# ADMINISTRATIVE AMENDMENT

**LEGACY 1 @ JOURNAL CENTER**  
5101 LANG AVENUE NE  
ALBUQUERQUE, NEW MEXICO 87109

PATIO SHADE SAILS

MARIGOLD CAFE

**A1 ROOF FRAMING PLAN**  
1/8" = 1'-0"

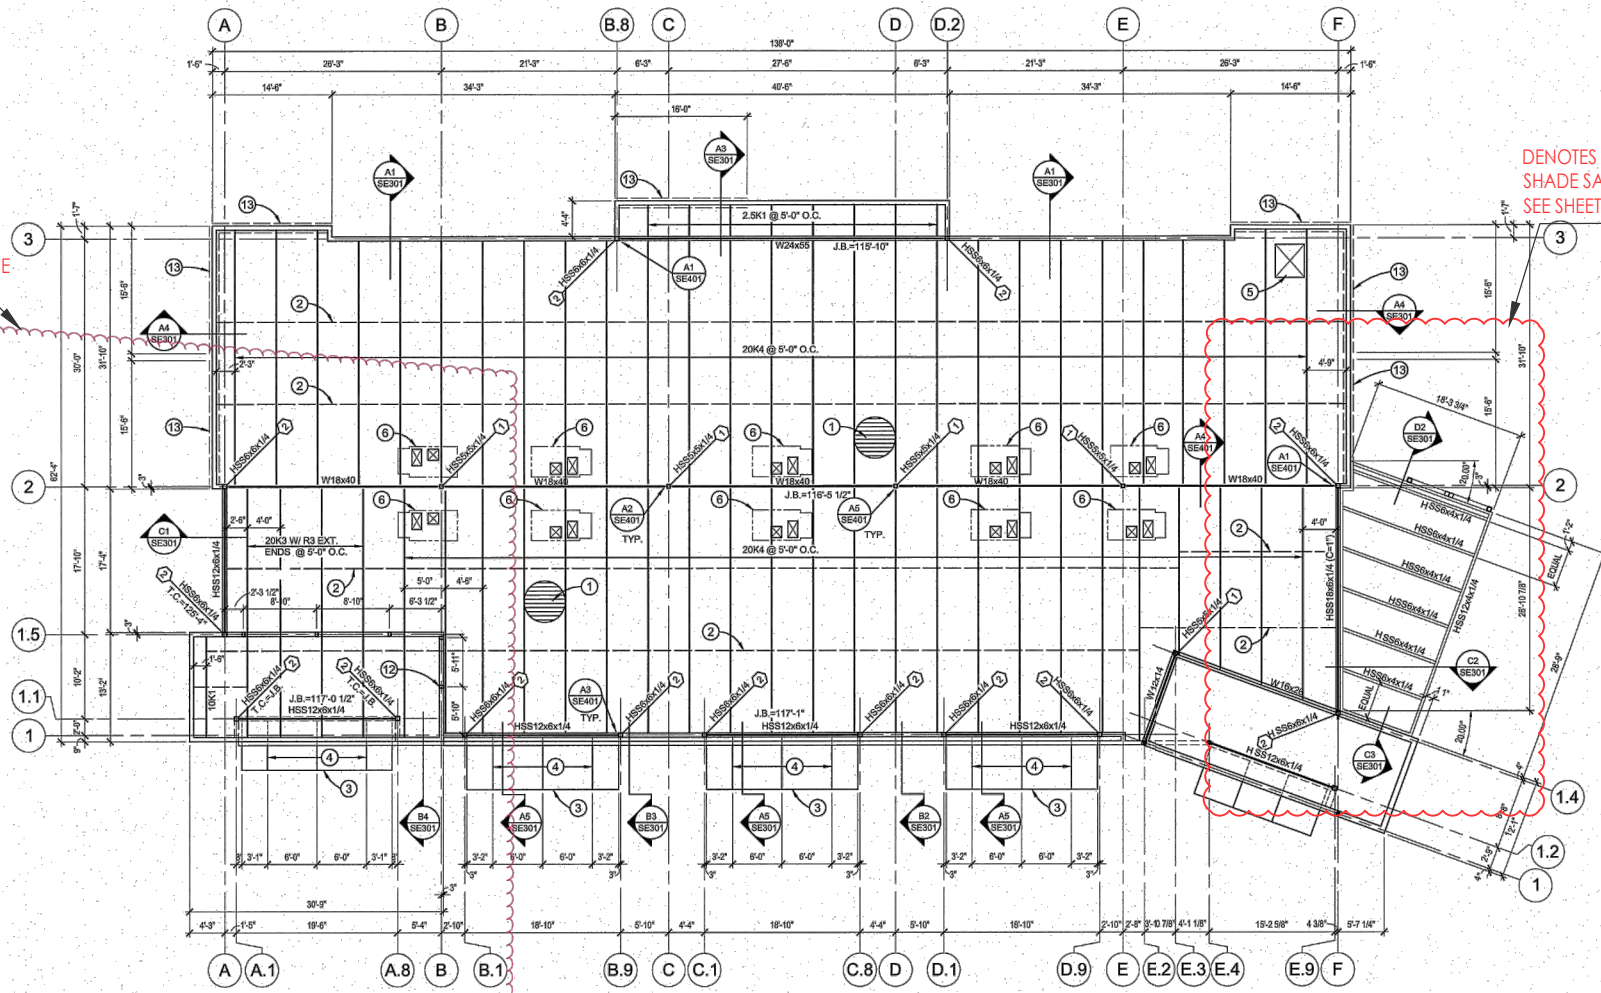
DENOTES AREA FOR PATIO SHADE SAILS. SEE SHEET 1 OF 2 FOR REFERENCE

DENOTES AREA FOR PATIO SHADE SAILS. SEE SHEET STRUCT001 REFERENCE
